## TDL #275 and #276 D2.1

### PSE-PD stability

#### 33A.1 Recommended PSE design guidelines and test setup

Figure 33A–1—PSE-PD system impedance allocation

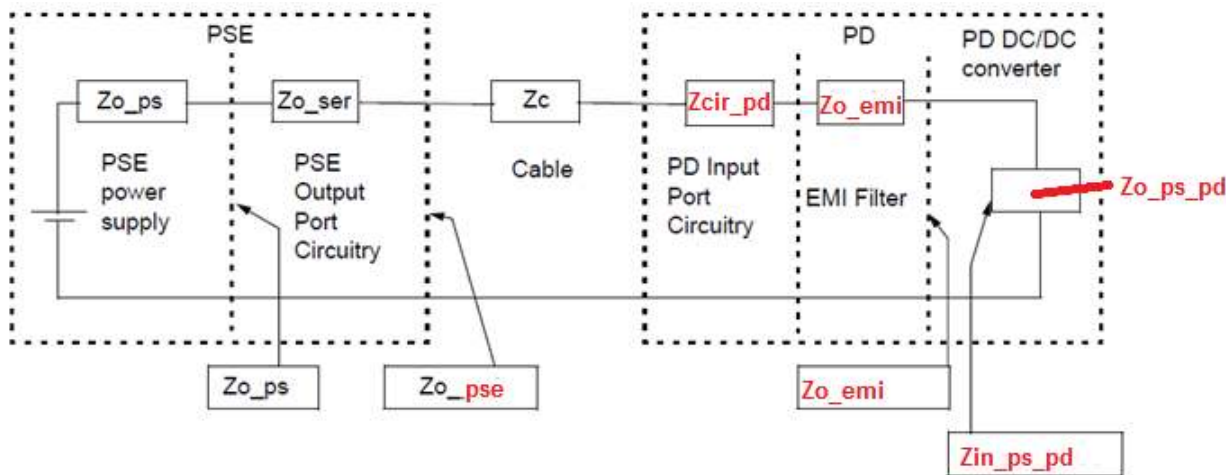
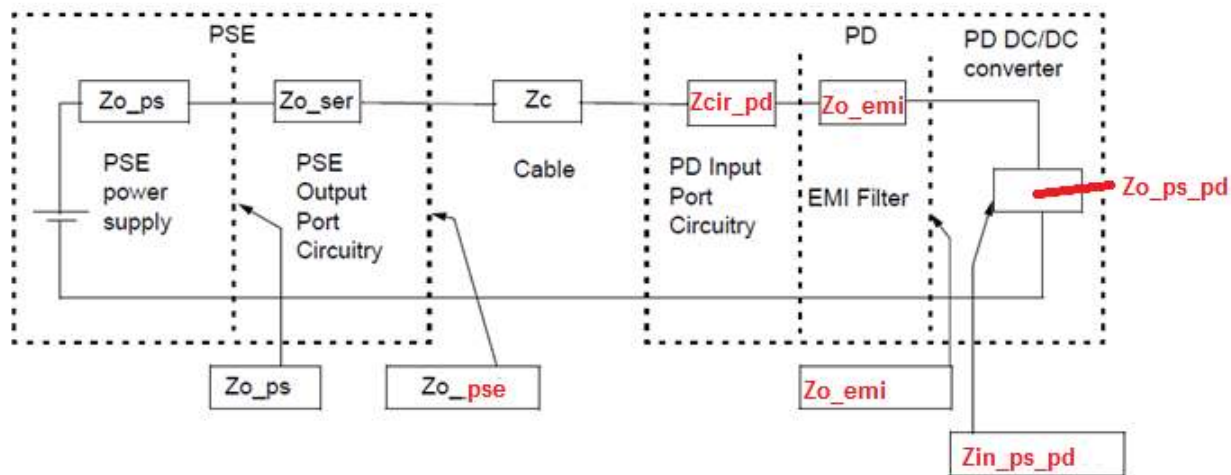
2. Update Figure 33A-1 as follows:
